**GUNNISON COPPER PROJECT
COCHISE COUNTY, ARIZONA
AQUIFER PROTECTION PERMIT APPLICATION
INVENTORY NO. 511633
RESPONSE TO COMMENTS**

APRIL 2017

FIGURE 9-1
Discharge Impact Area and
PMA Boundary

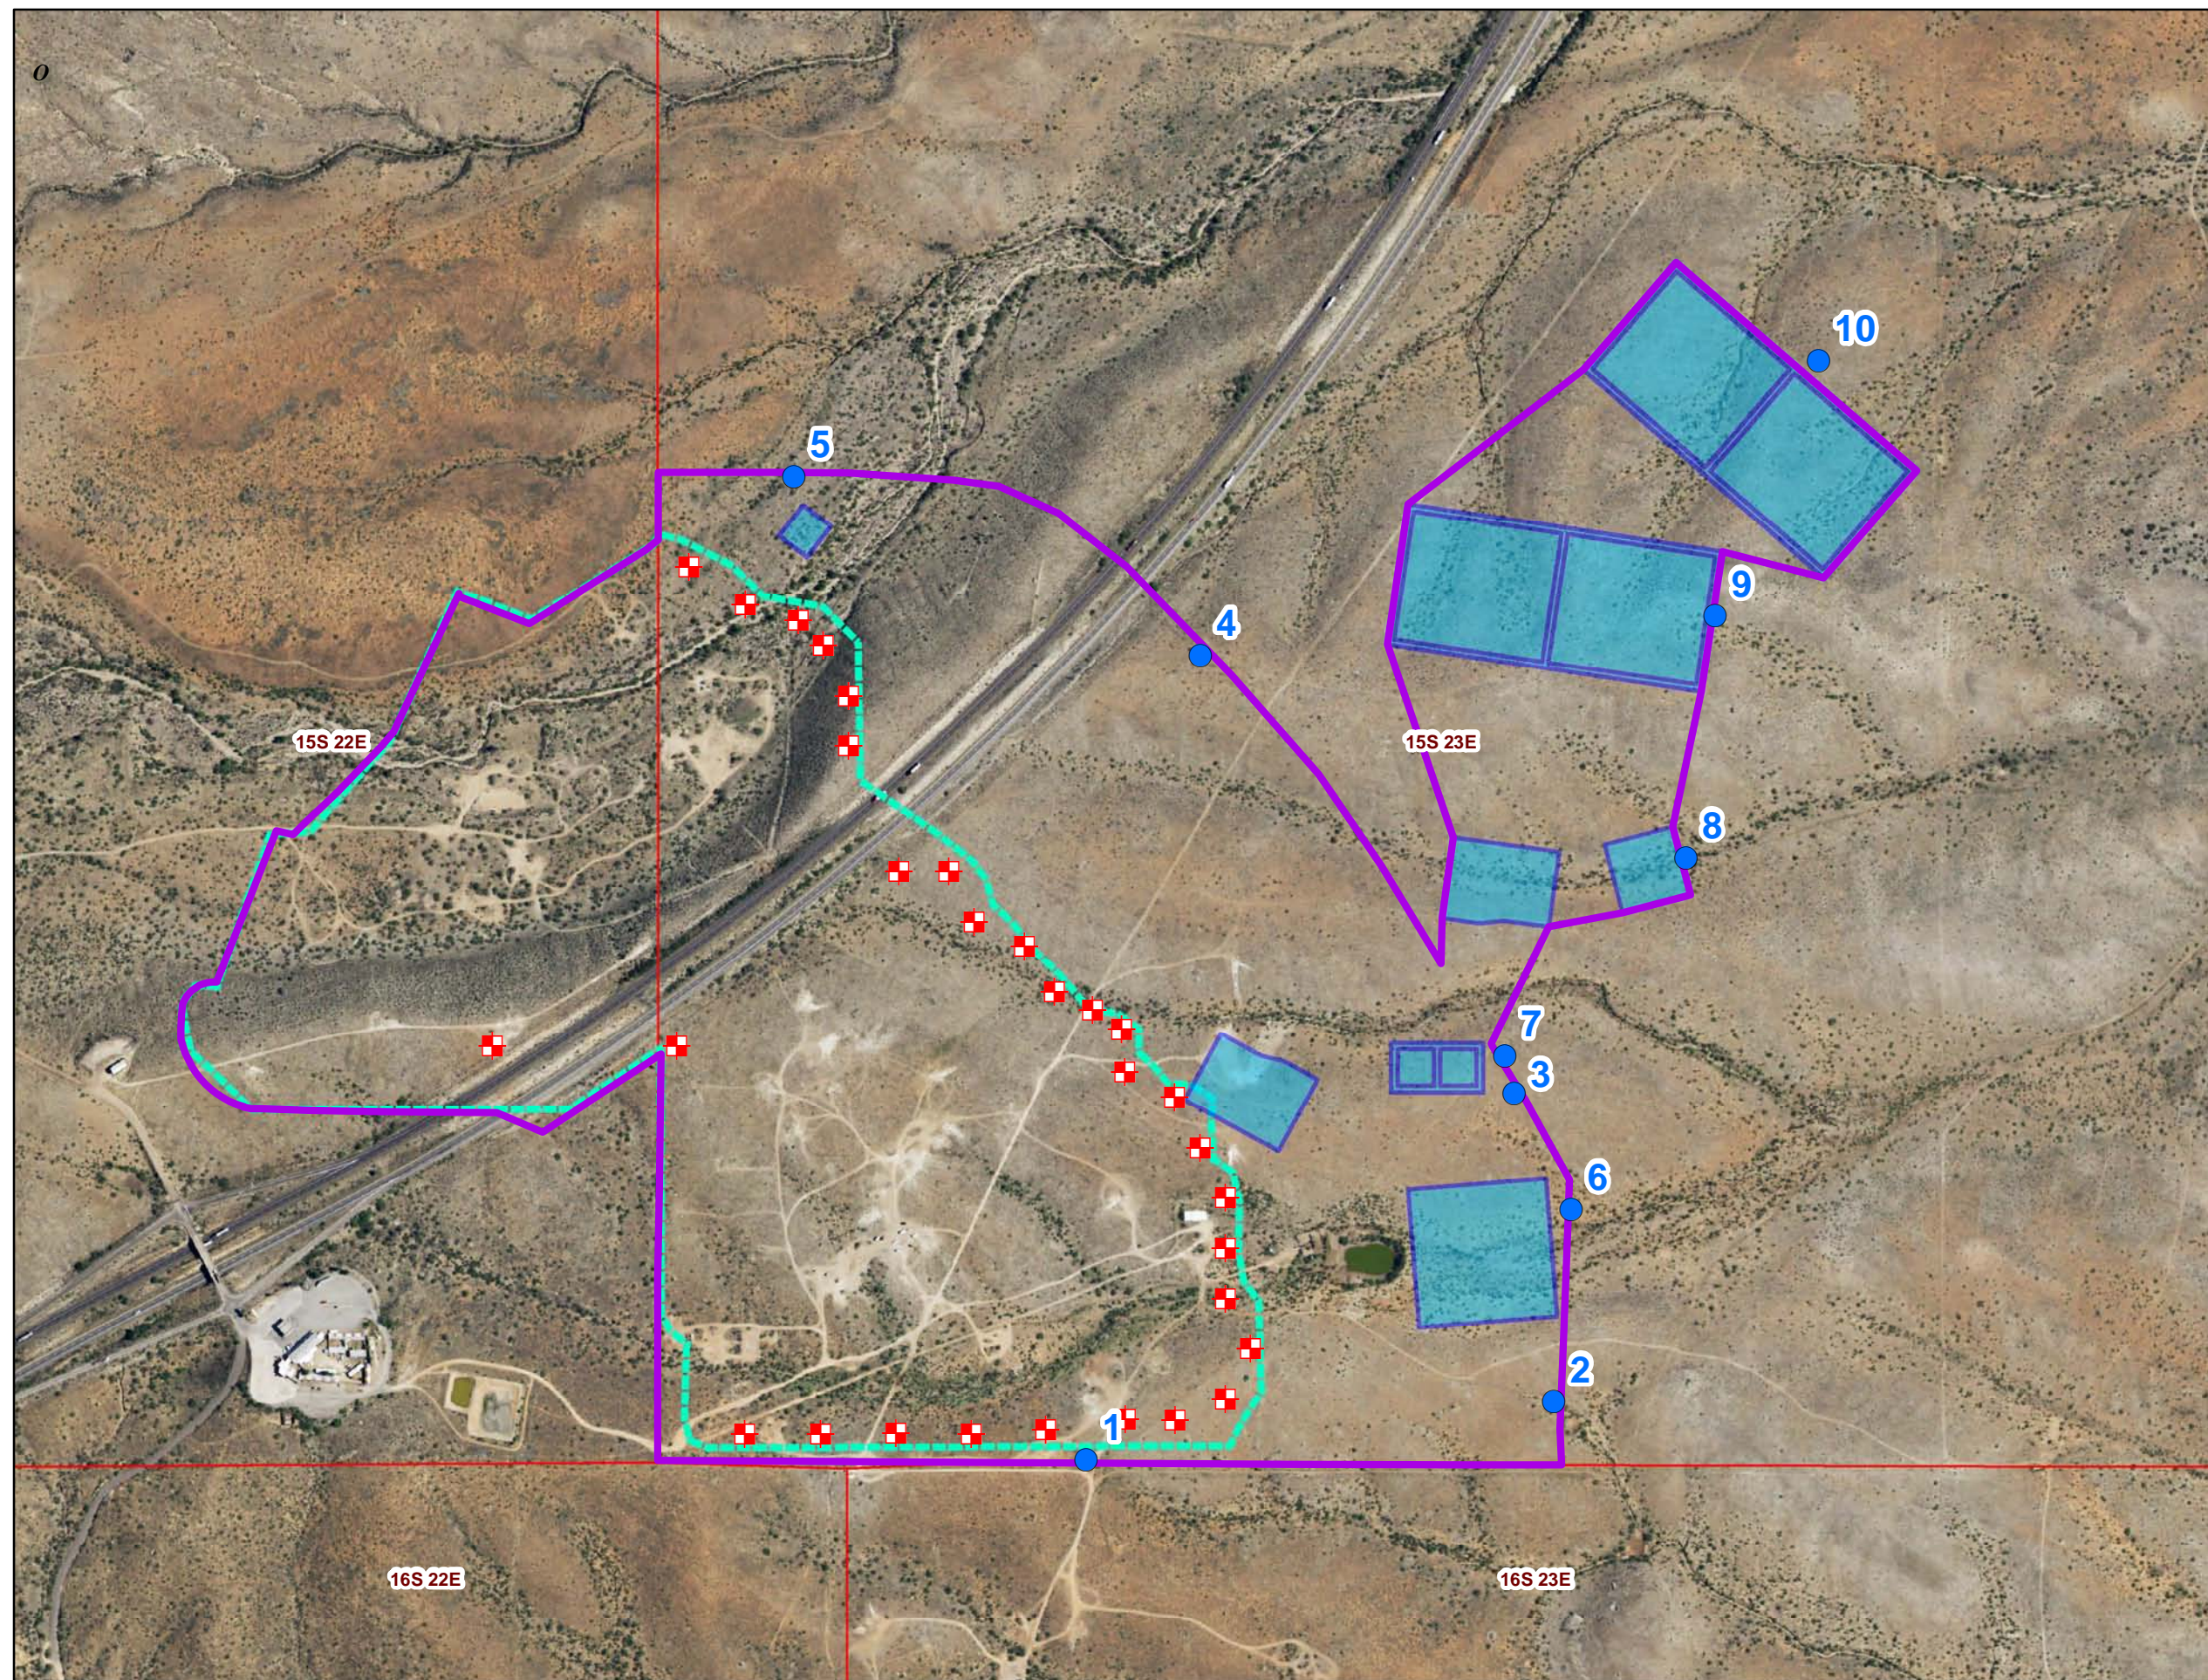
Figure 9-1 Revised Discharge Impact Area 23 Year Simulation shows discharge impact areas (DIA) that are not the same as the footprint of the lined impoundments. Please provide a discussion on why the DIA for the lined facilities are showing that there will be releases from those facilities per A.A.C. R18-9-A202(A)(5) and A.A.C. R18-9-A202(A)(8)(b)(xiii).

Excelsior has revised Figure 9-1 so that the discharge impact areas for the ponds coincides with the footprints. We did not intend to show that there will be releases from the ponds. They will be constructed using prescriptive BADCT and no releases are expected.

FIGURE 12-1
Potential Water Supply Wells
near Johnson Camp Mine

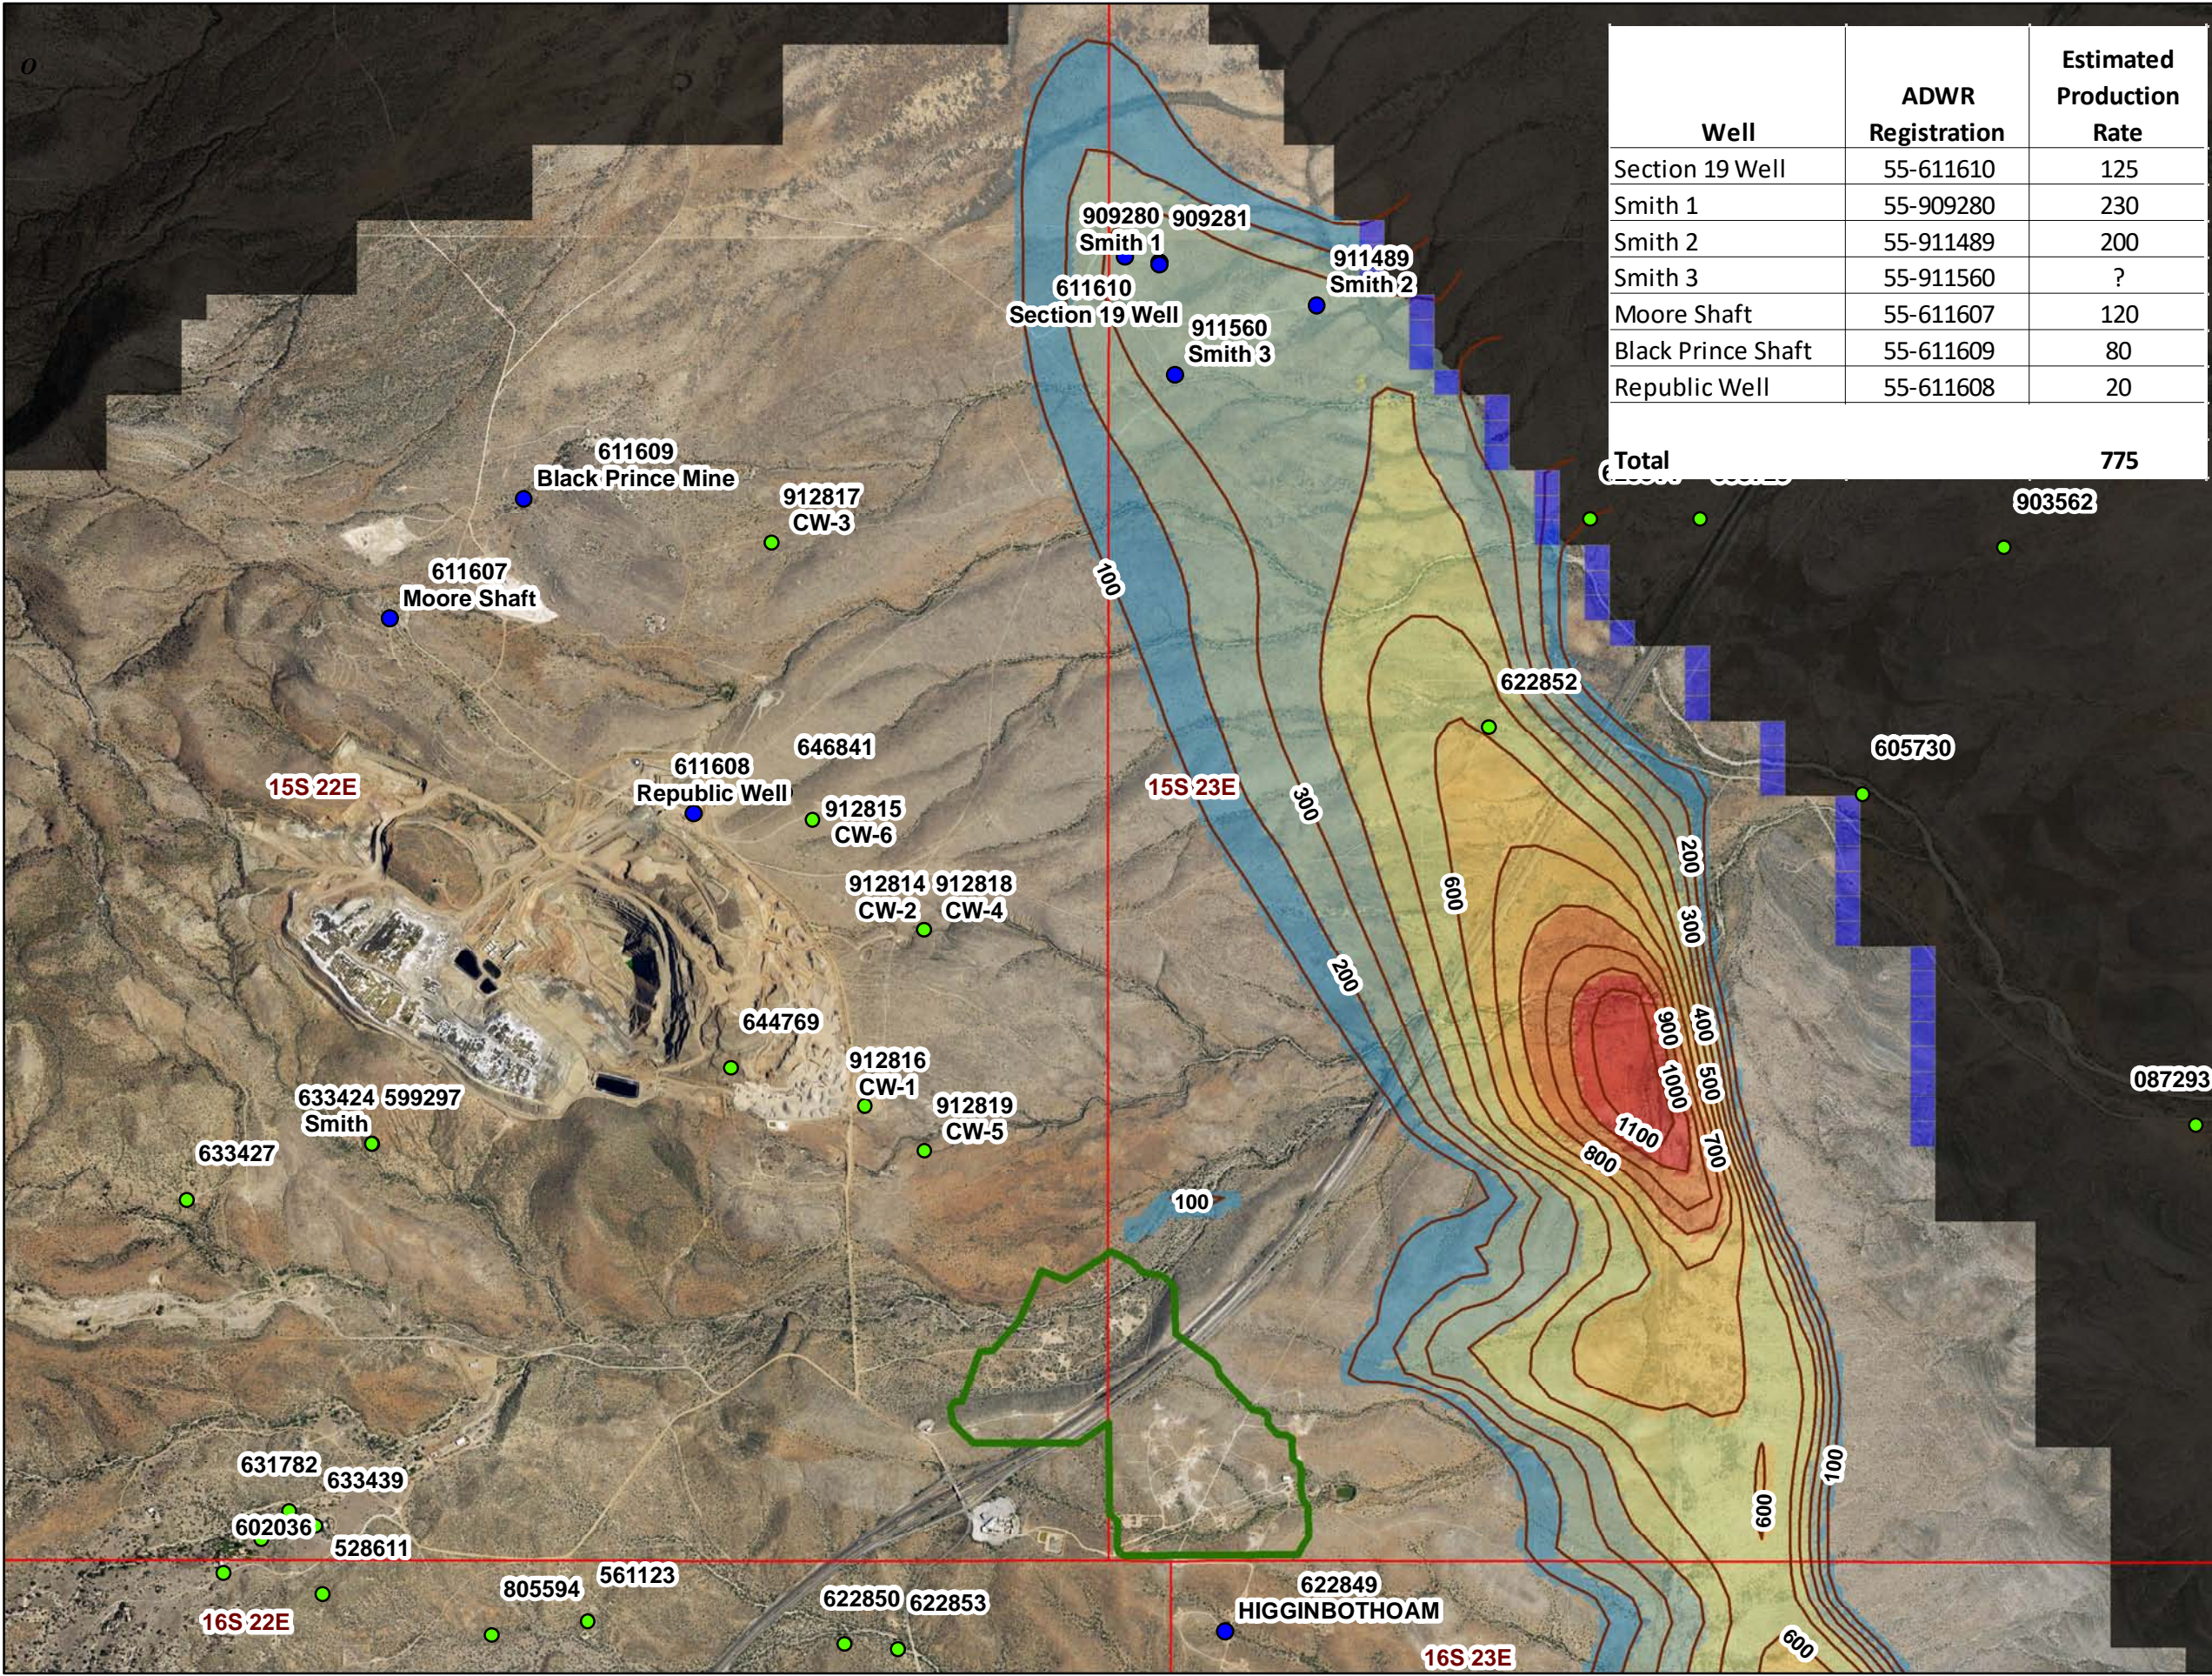
Sources of clean water include five potential sources: Johnson Camp Mine (JCM) Section 19 well (55-611610); Smith Well 1 and 2 (55-909280 and 55-911489); Smith Well #3 (55-911560); the Moore Shaft at JCM; and unimpacted water from hydraulic control wells. ADEQ requests that each potential source of clean water be represented on a figure containing the mine blocks. The volume of clean water that may be used from each source should also be provided with a discussion on whether the groundwater flow model included an evaluation of how this pumping may impact capture.
